CLAREMONT BUSINESS PARK 2 FIL. NO. 1 - LOT 5

EL PASO COUNTY, STATE OF COLORADO
GRADING & EROSION CONTROL PLAN

EPC STORMWATER REVIEW COMMENTS
IN ORANGE BOXES WITH BLACK TEXT

GRADING & EROSION CONTROL PLAN
CLAREMONT BUSINESS PARK 2 FIL. NO. 1 – LOT 5
JOB NO. 44-037
DATE PREPARED: JULY 17, 2020
DATE REVISED: SEPT 4, 2020

GRADING & EROSION CONTROL PLAN
CLAREMONT BUSINESS PARK 2 FIL. NO. 1 - LOT 5
JOB NO. 44-037
DATE PREPARED: JULY 17, 2020
DATE REVISED: SEPT 4, 2020

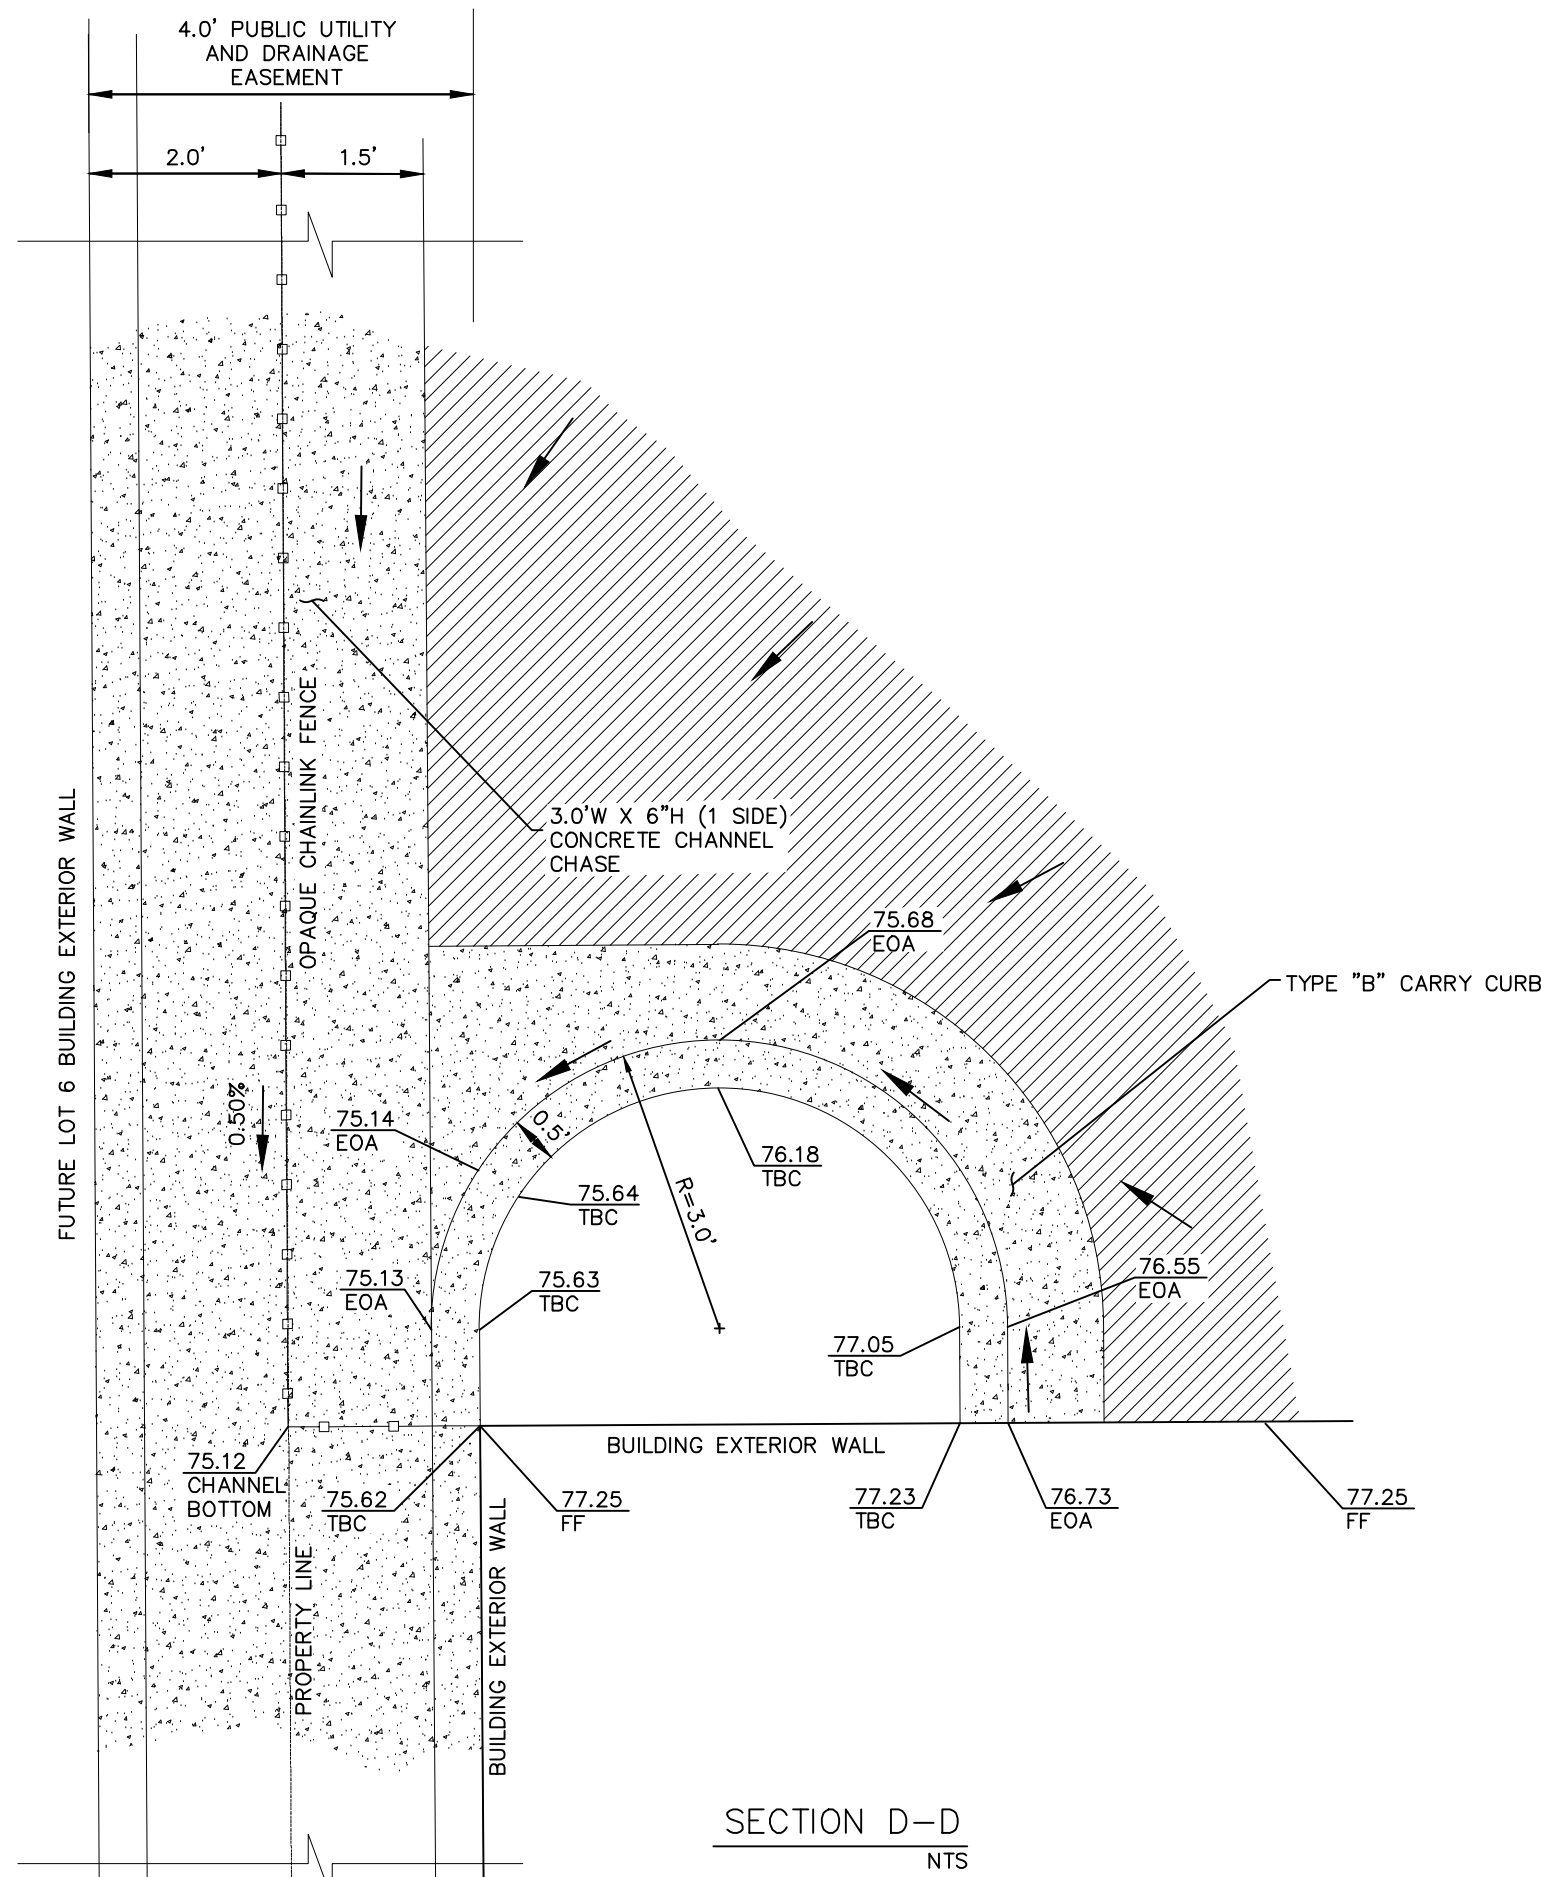
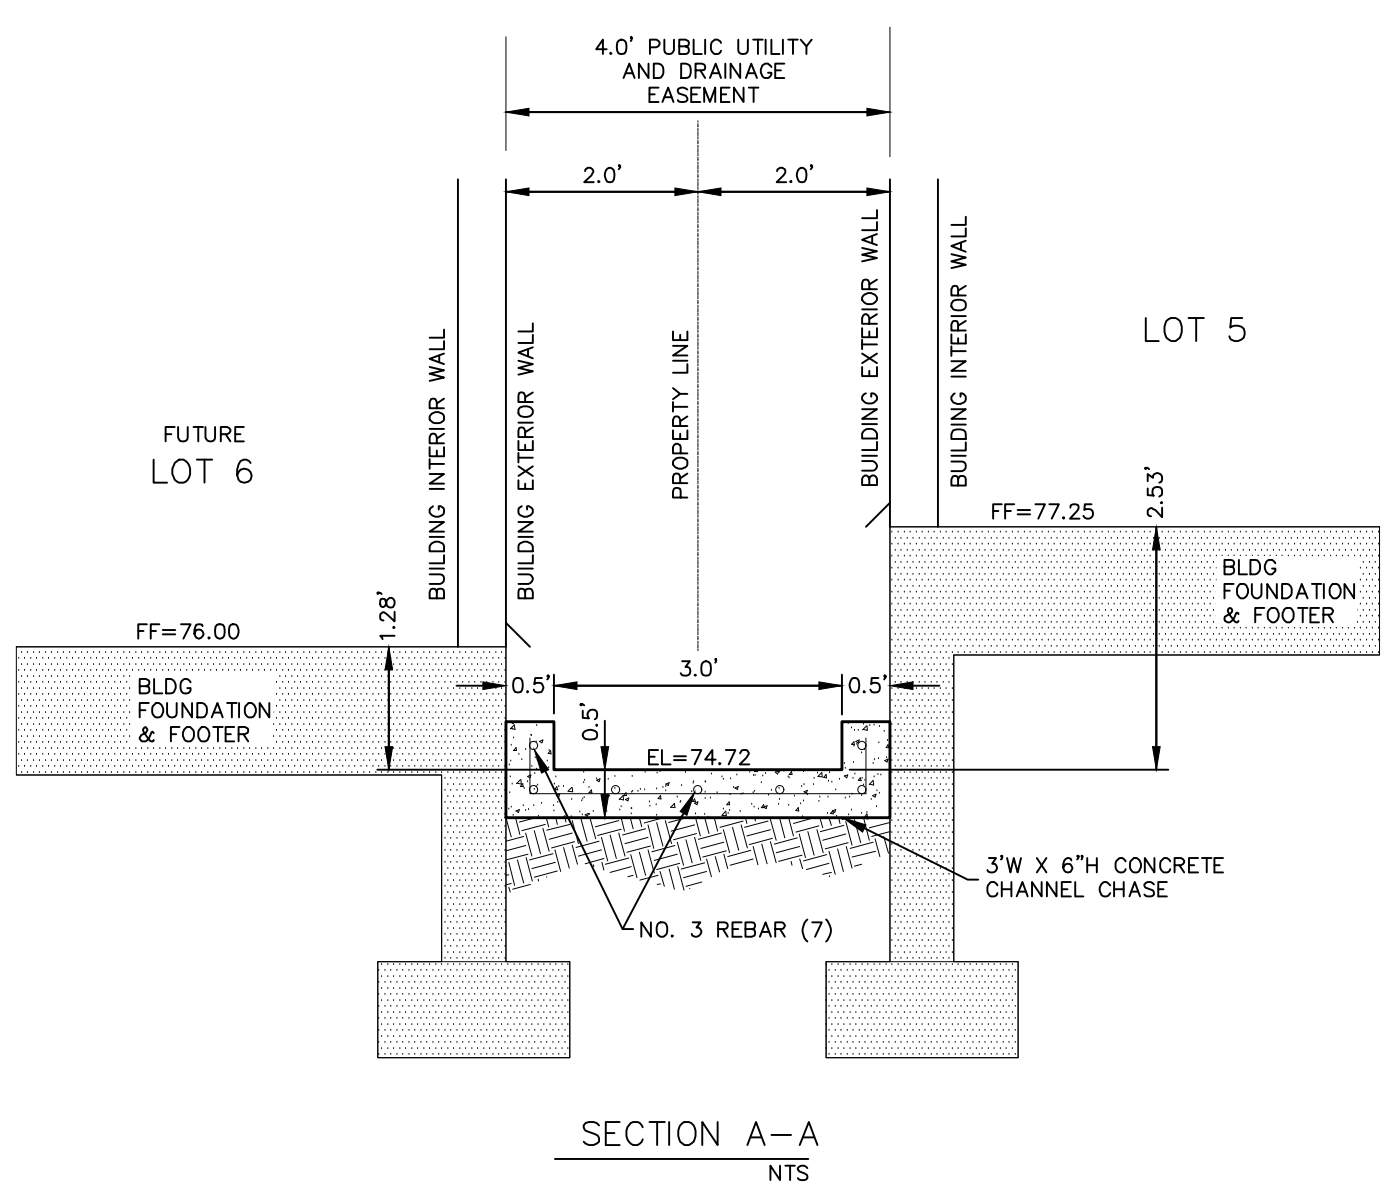
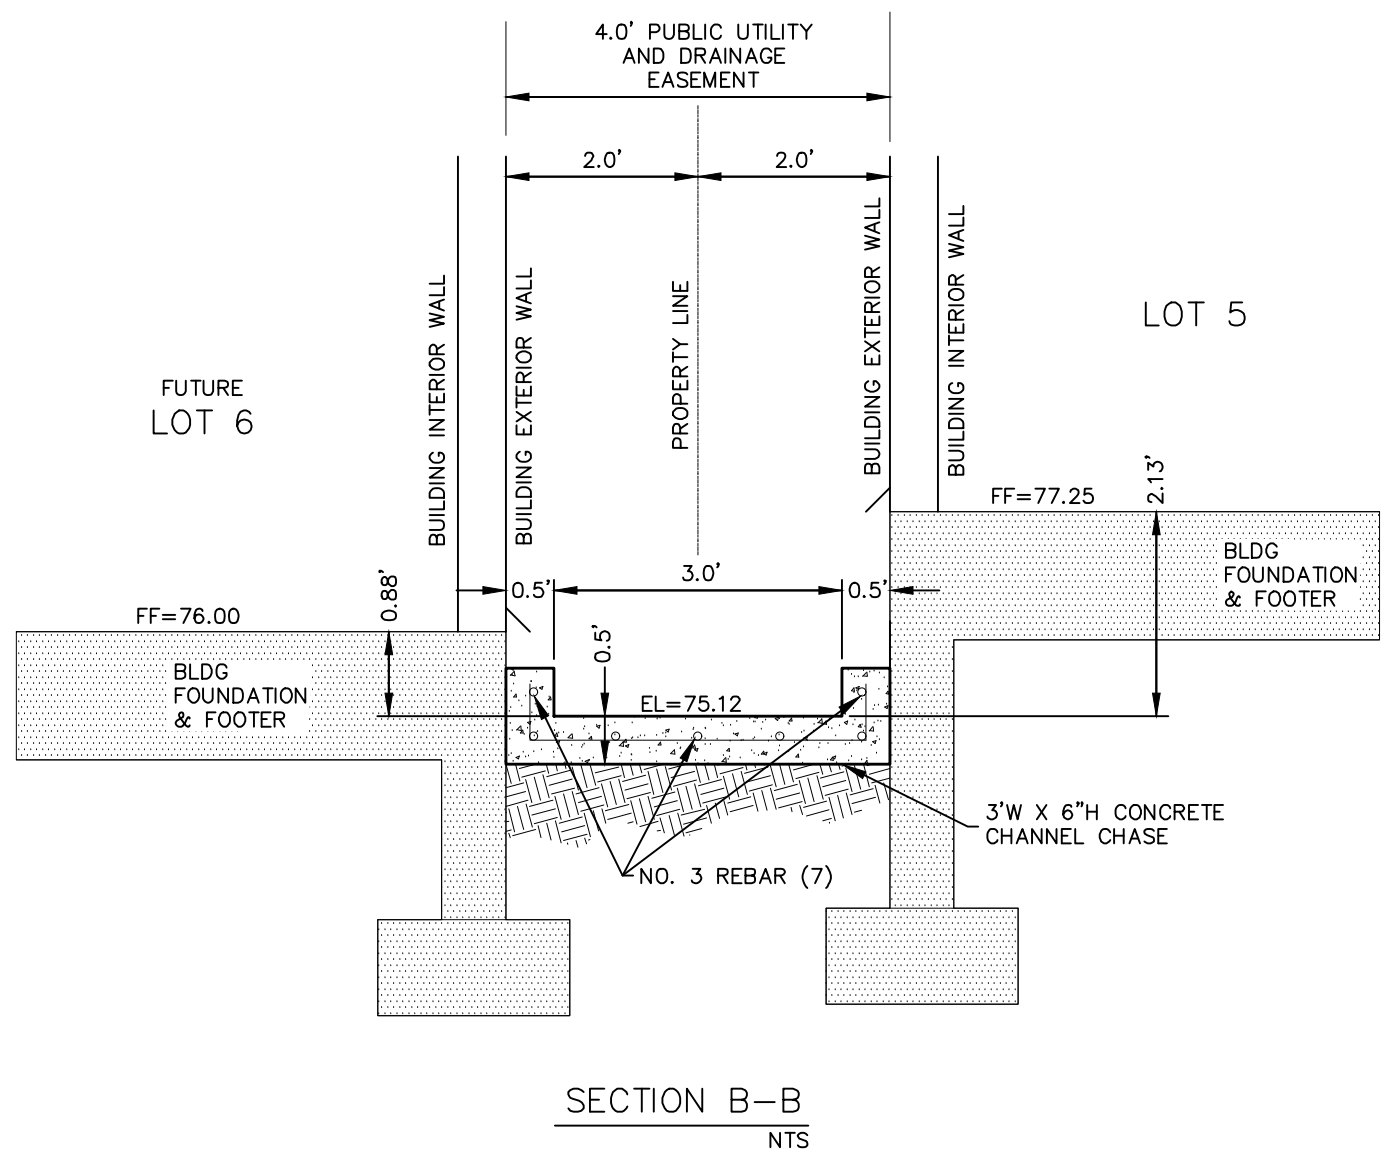
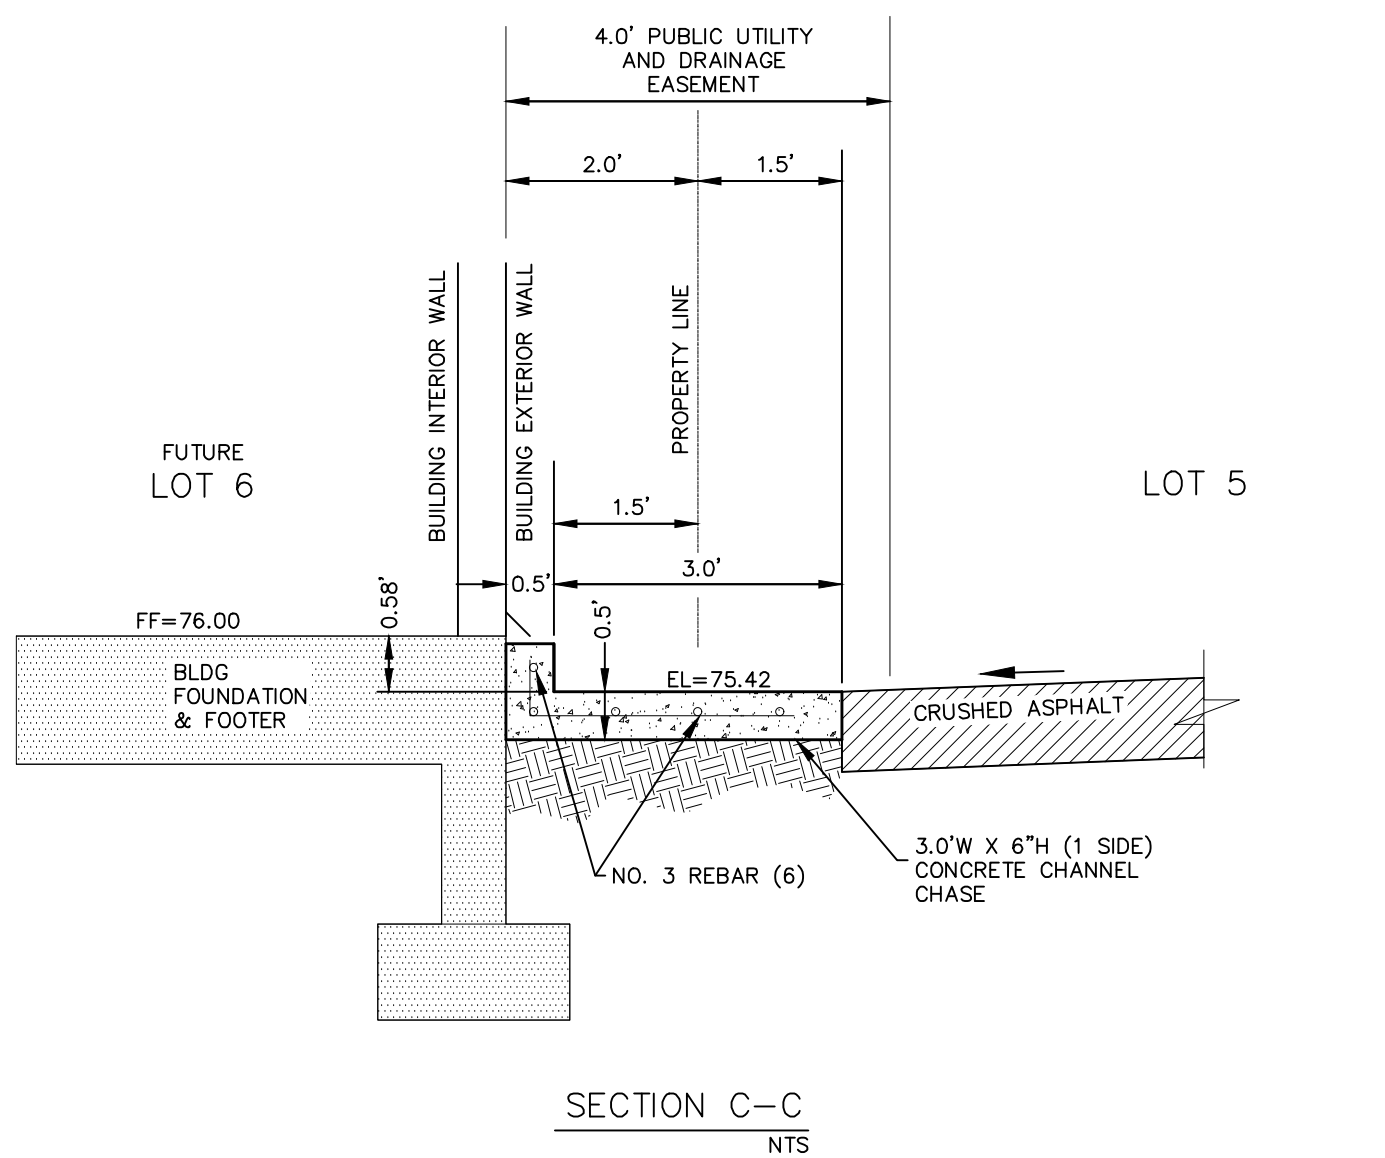
include details for CWA, Seeding/Mulching, SF, SSA, and VTC (w/ min 75ft length)

Details added as requested see sheet 4
